MULTI-MODEL

AUTOMATIC TRANSMISSION OIL PAN BOLTS (UPDATE)

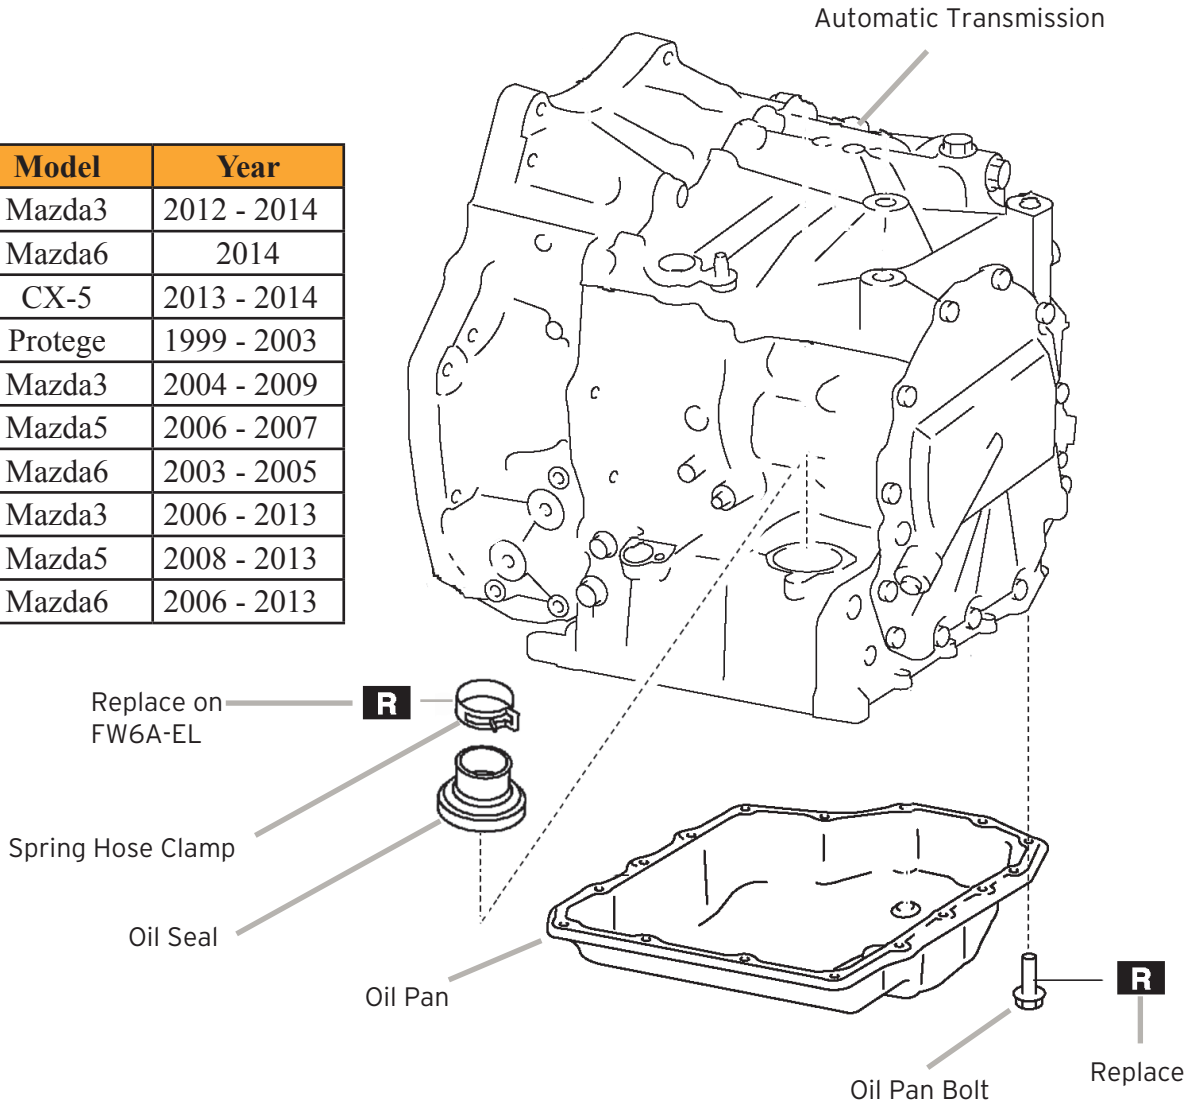
If an automatic transmission oil pan removal is necessary on a transmission listed below, an engineering change has taken place. The automatic transmission oil pan bolts cannot be reused. Install new bolts when installing the oil pan.

- If the control valve body removal is necessary on a FW6A-EL transmission, install a new spring hose clamp when installing the control valve body.
- Workshop Manuals are being revised to reflect these changes.
